AIR - PROVIDE HPT ACC TUBES WITH IMPROVED MAINTAINABILITY FEATURES - CATEGORY CODE 7 -
MOD.ENG-75-0013

V2500-ENG-75-0013

**SERVICE BULLETIN**

Modification of 2A0202 and 2A3665 Turbine Cooling Manifold
Fig.1 (Sheet 1 of 2)

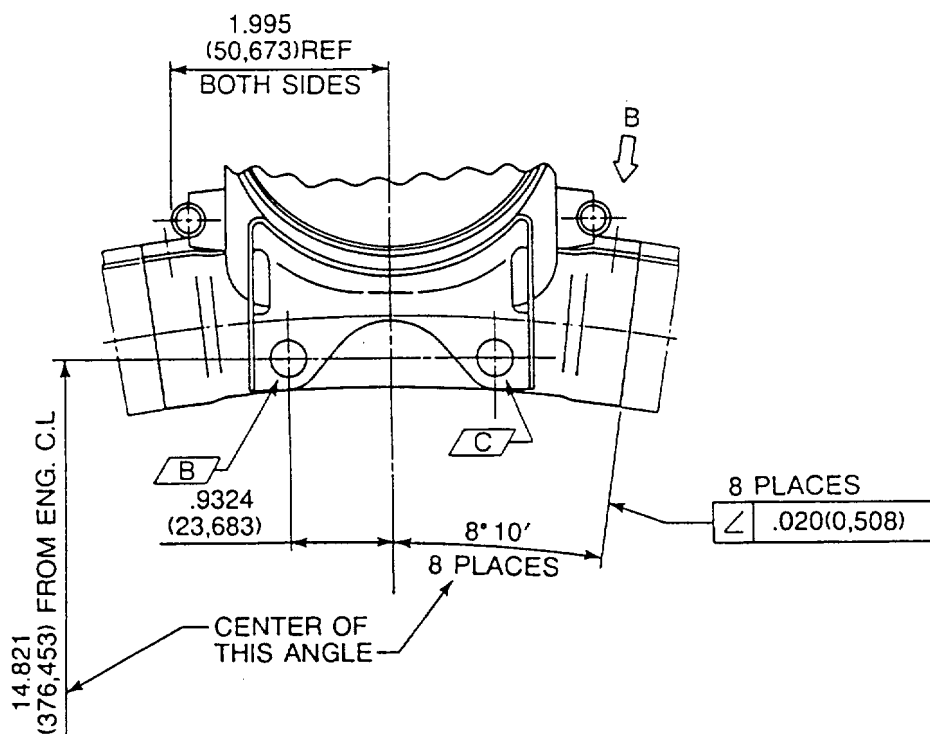
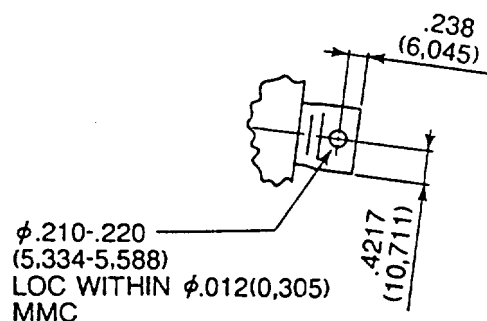
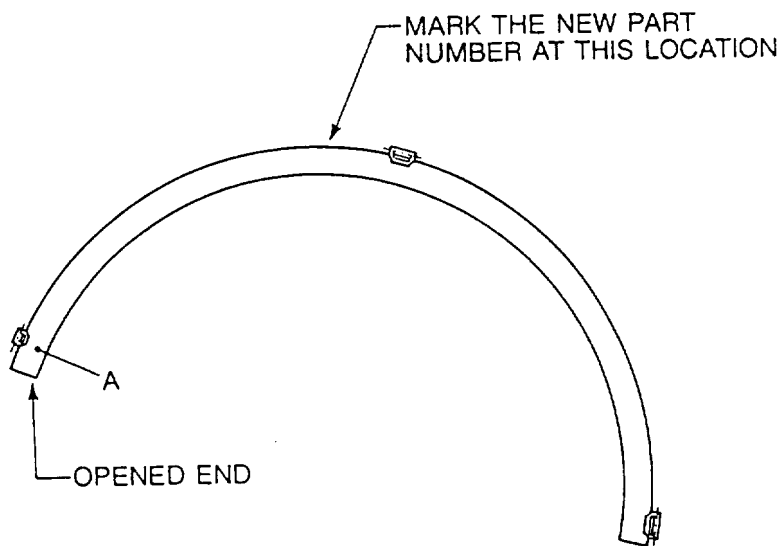
- (i) 2A1540 Turbine Cooling Manifold supersedes 2A0202 Turbine Cooling Manifold. 2A1569 Turbine Cooling Manifold supersedes 2A3665 Turbine Cooling Manifold. 2A1540 and 2A1569 Turbine Cooling Manifolds provide shortened tubes and the tubes have bolt holes.

Procedure	Supplementary Information	
(a) Set-up and machine the Turbine Cooling manifold to the dimensions specified	Refer to Figure 1 requirements	
(i) Cut the tubes of Turbine Cooling Manifold to the dimensions specified		
(ii) Drill eight holes		
(iii) Remove burrs and sharp edges

(b) Re-identify modified Turbine Cooling Manifold. Use the vibration peen method	Old Part No.	New Part No.
	2A0202	2A1540
	2A3665	2A1569
	Refer to Figure 1 requirements and Reference (6), 70-11-00, Marking of Parts

Modification of 2A0220, 2A0225, 2A0229, 2A0233, 2A0223, 2A0227, 2A0231 and 2A0235 TCC
Tubes

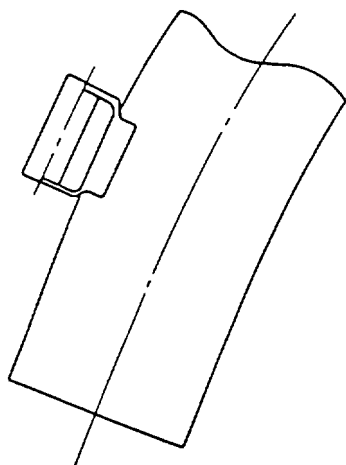
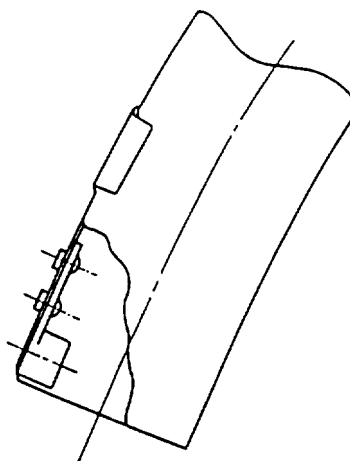
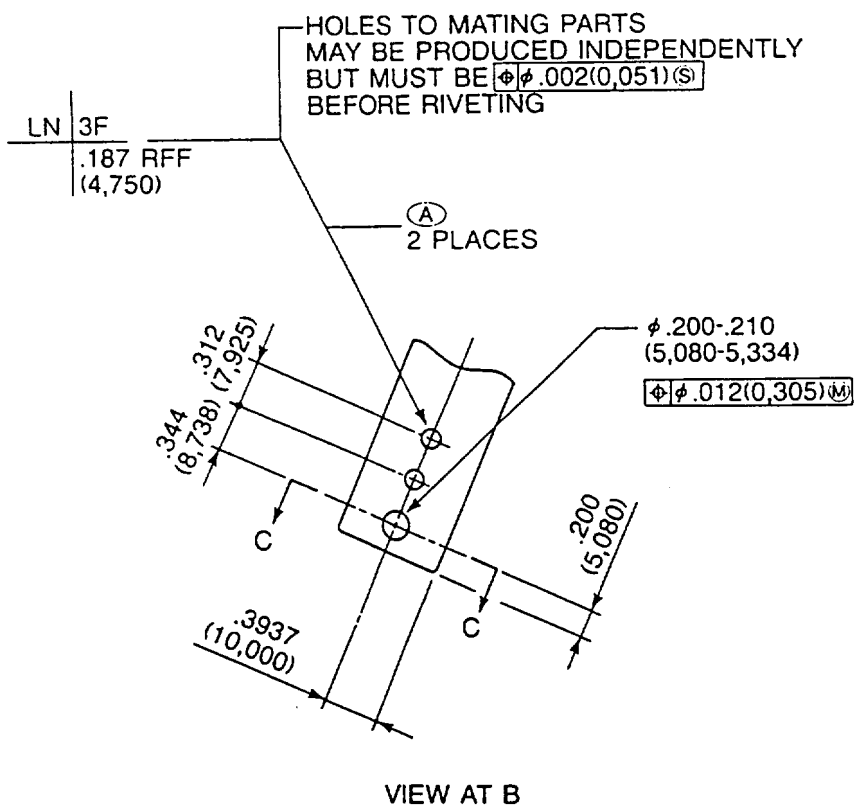
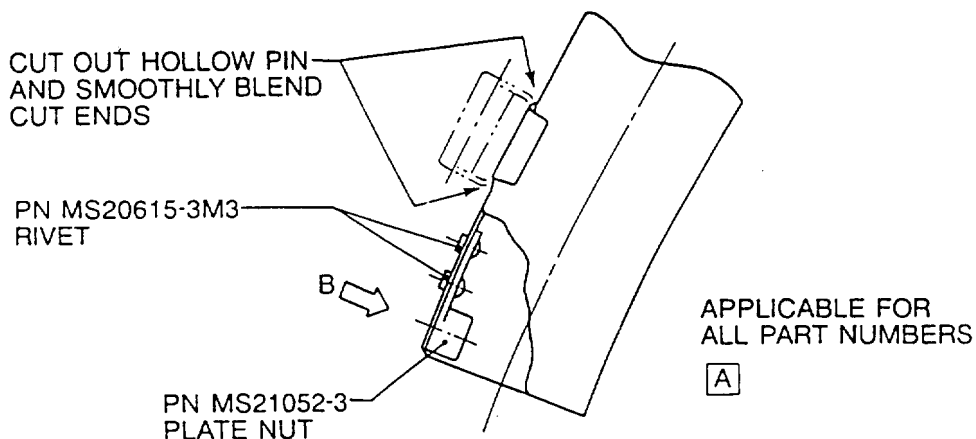
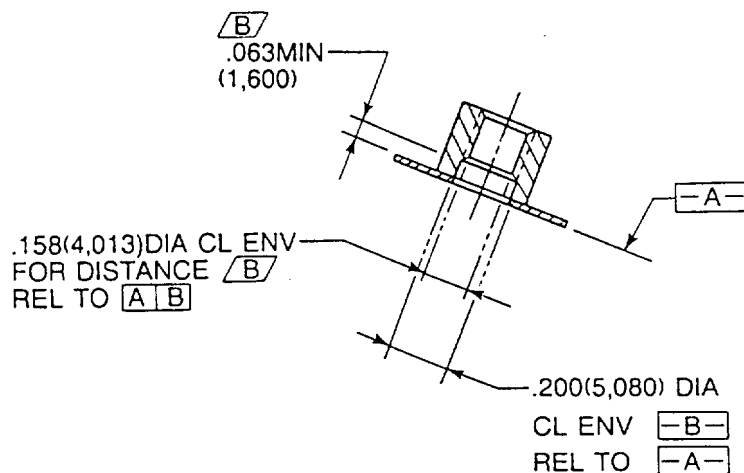
- (ii) Existing eight TCC tubes are superseded by new TCC tubes which each have MS21052-3 Plate Nut at the opened end side. Assemblies of these tubes, 2A1561 R/H Turbine Cooling Manifold Assembly and 2A1562 L/H Turbine Cooling Manifold Assembly, supersede 2A1571 R/H Turbine Cooling Manifold Assembly and 2A1572 L/H Turbine Cooling Manifold Assembly. For the part number transaction, refer to 3. Material Information Section of this Bulletin.

- (a) Remove a Hollow Pin which positions opened end side of each TCC Tube
- (i) Cut off the Hollow Pin from the TCC Tube. Blend the cut ends and remove sharp edges

- (ii) Examine the blended area for cracks
- (b) Drill three holes to each TCC Tube
- (i) Drill three holes
- (ii) Remove burrs and sharp edges
- (c) Install MS21052-3 Plate Nut to each TCC Tube.

- (i) Place MS21052-3 Plate Nut in position
- (ii) Insert and upset two MS20615-3M3 Rivets
- (d) Examine installed Plate Nut
- (i) Examine the Rivets
- (ii) Examine dimensions

- (e) Re-identify modified TCC Tubes. Use the vibration peen method
- Refer to Figure 2 requirements
- Refer to Reference (6), 70-23-05 Penetrant Inspection

Change of Brackets on FM Flange
Fig.3

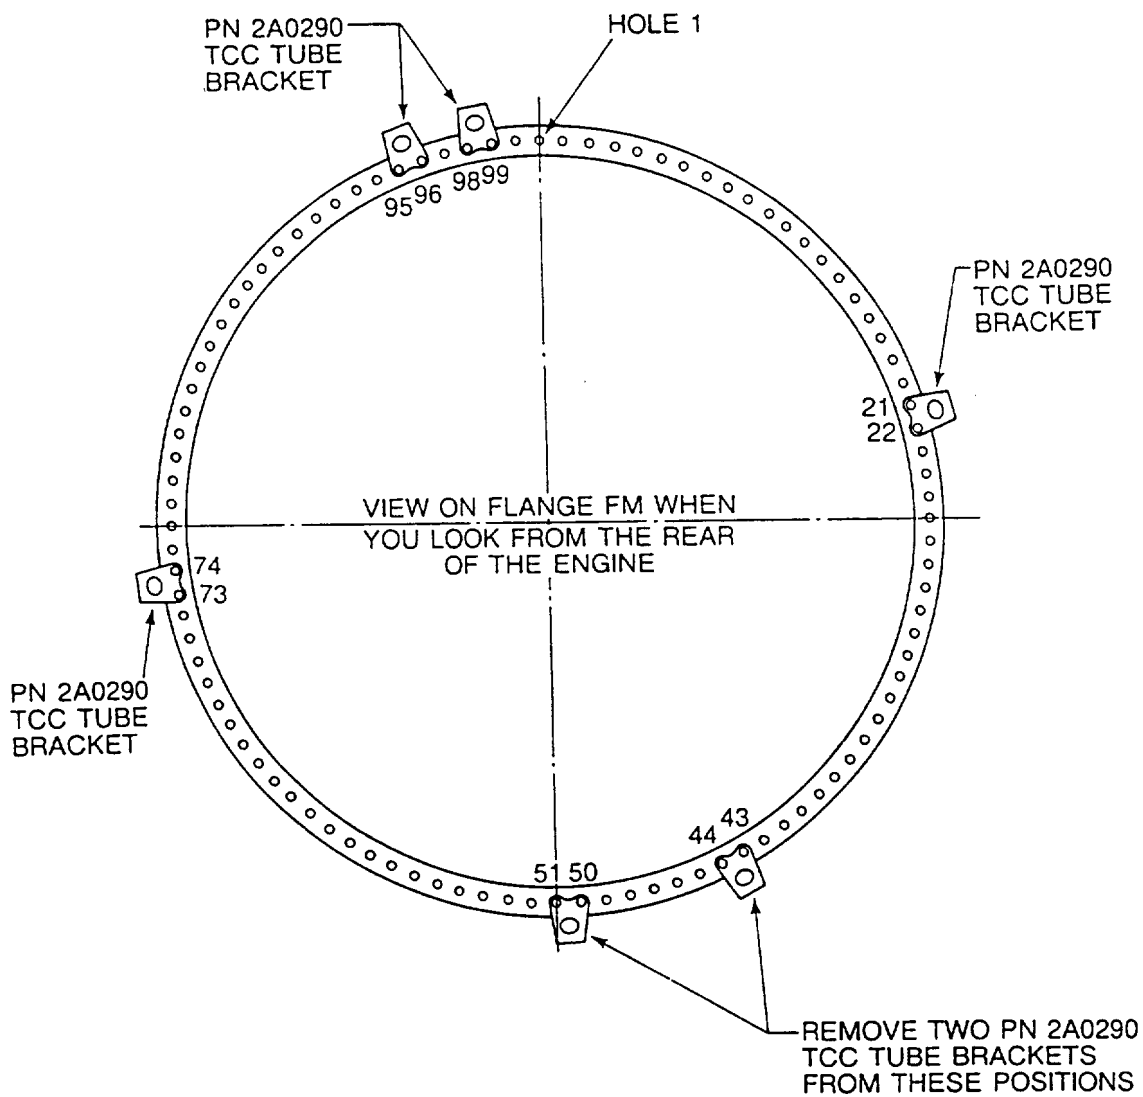
- (a) Install four 2A0290 TCC Tube Bracket to FM flange when install HP Turbine Assembly or assemble HP System Module. Refer to Figure 3 and Reference (3), 72-00-45, Installation and 72-40-00, Assembly.

Change of Brackets on FN Flange
Fig.4

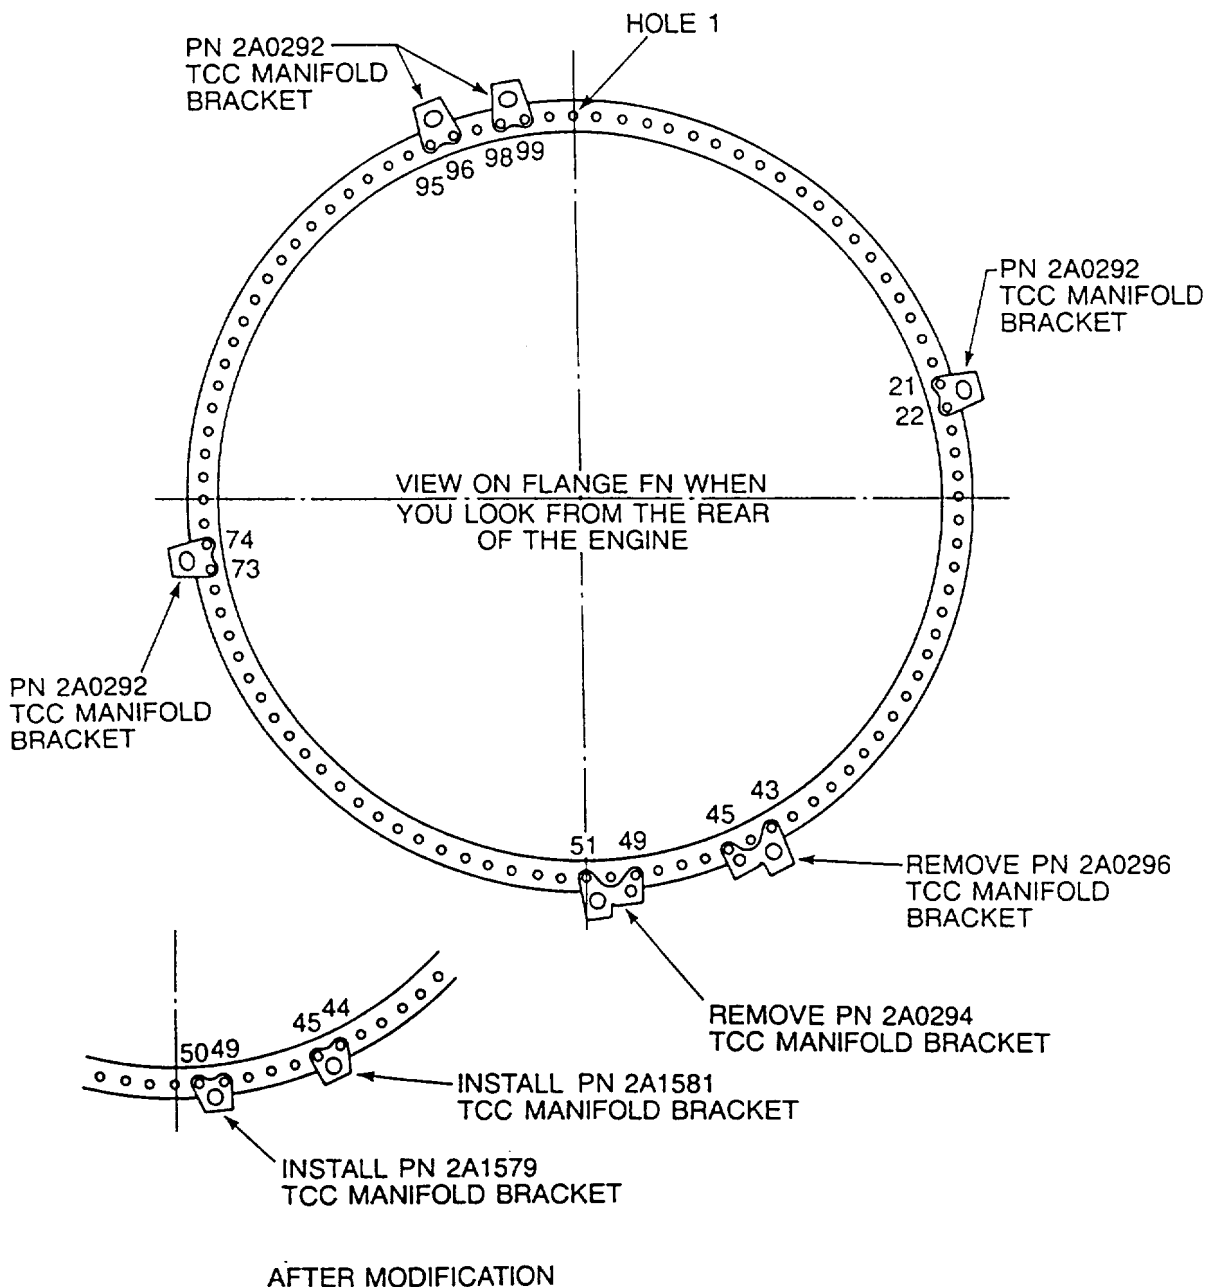
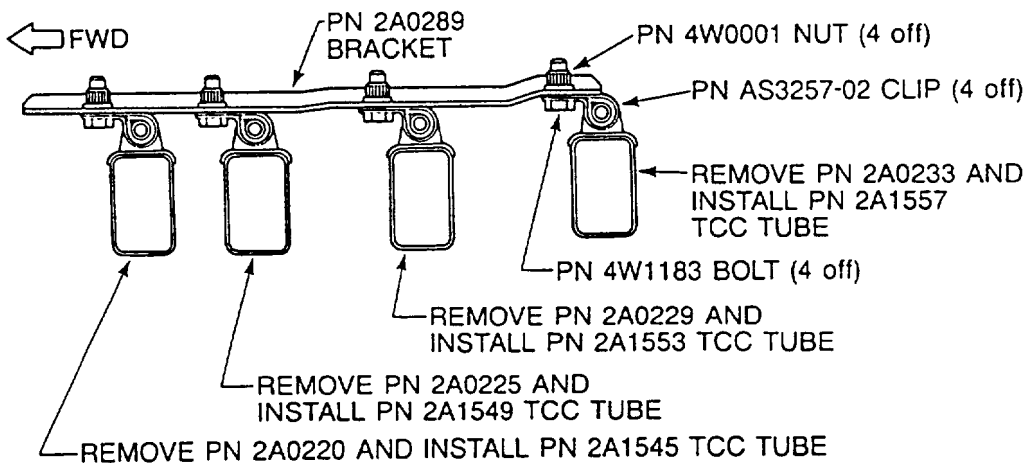
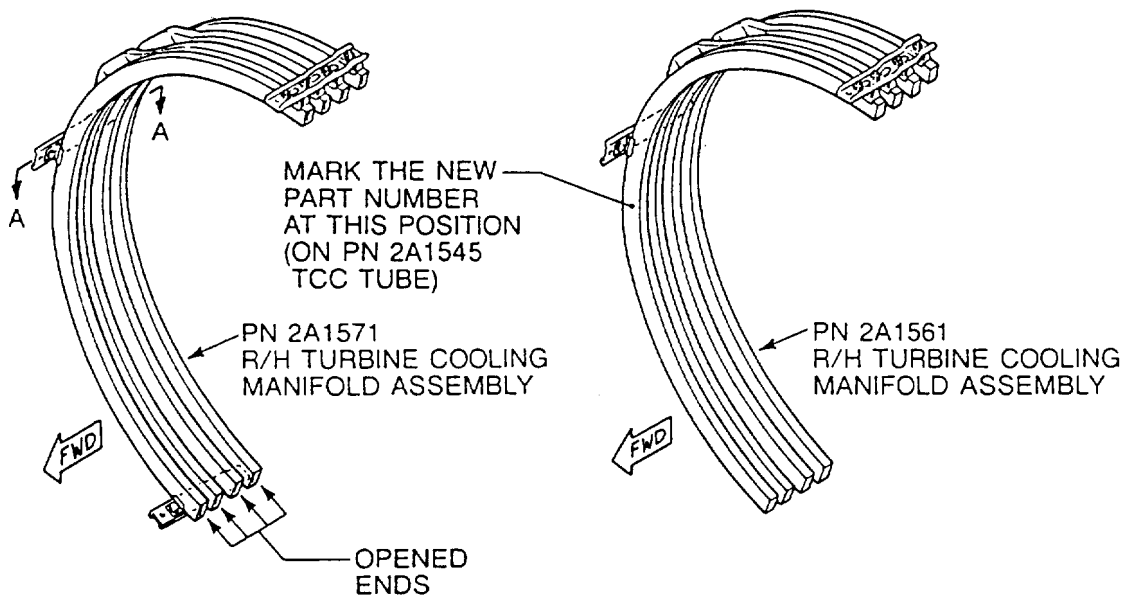
- (b) Install 2A1581 and 2A1579 TCC Manifold Brackets to FN flange when install LP Turbine module. Refer to Figure 4 and Reference (3), 72-00-50, Installation.

Modification of R/H Turbine Cooling Manifold Assembly
Fig.5

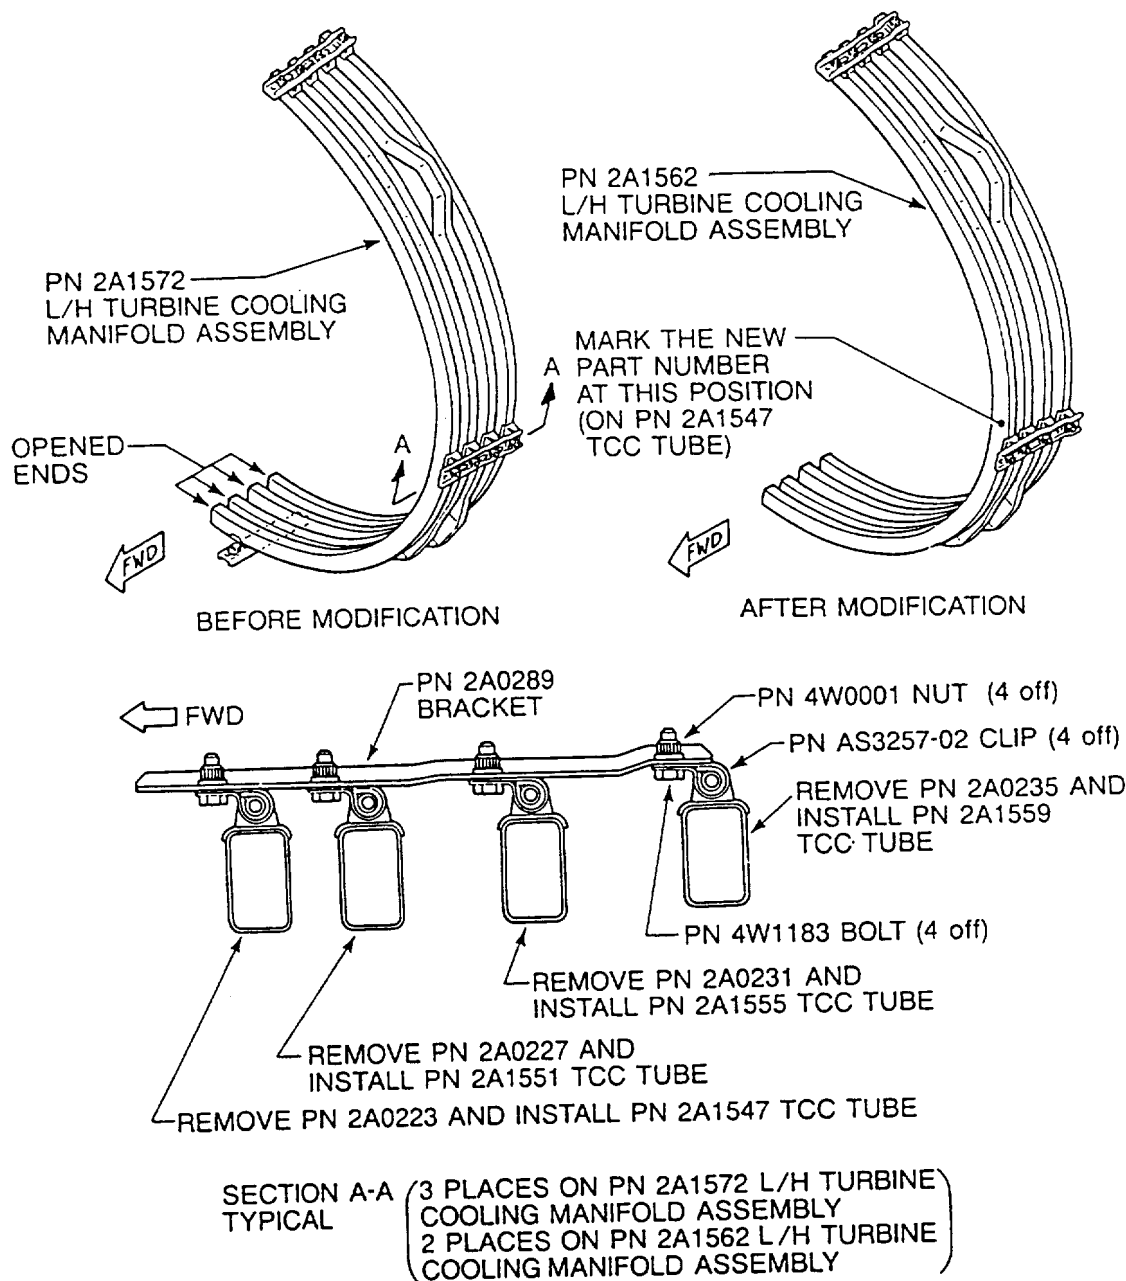
- (a) Assemble 2A1561 R/H Turbine Cooling Manifold Assembly. Refer to Figure 5.

- (i) Install eight AS3257-02 Clips to the Hollow Pins of 2A1545, 2A1549, 2A1553 and 2A1557 TCC Tubes.

- (ii) Lubricate threads of eight 4W1138 Bolts with CoMat 10-077 approved engine oils. Install the Clips to two 2A0289 Brackets with the Bolts and eight 4W0001 Nuts.

- (iii) Torque the Nuts to 36 to 40 lbfin (4,00 and 4,52 Nm).

- (f) Re-identify part number of R/H Turbine Cooling manifold Assembly on 2A1545 TCC Tube. Use the vibration peen method

Modification of L/H Turbine Cooling Manifold Assembly
Fig.6

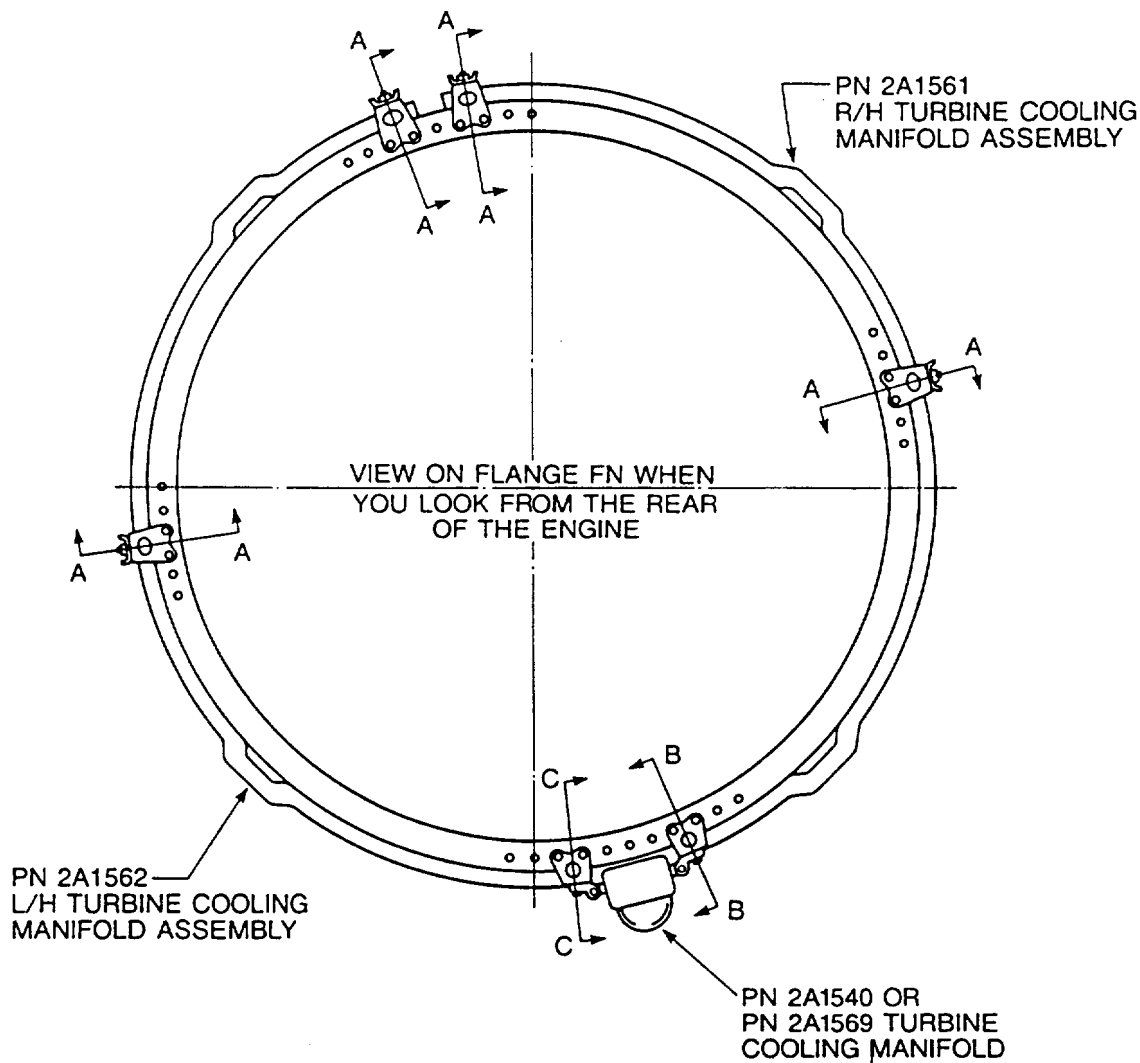
- (b) Assemble 2A1562 L/H Turbine Cooling Manifold Assembly. Refer to Figure 6.

- (i) Install eight AS3257-02 Clips to the Hollow Pins of 2A1547, 2A1551, 2A1555 and 2A1559 TCC tubes.

- (ii) Lubricate threads of eight 4W1138 Bolts with CoMat 10-077 approved engine oils. Install the Clips to two 2A0289 Brackets with the Bolts and eight 4W0001 Nuts.

- (g) Re-identify part number of R/H Turbine Cooling manifold Assembly on 2A1547 TCC Tube. Use the vibration peen method.
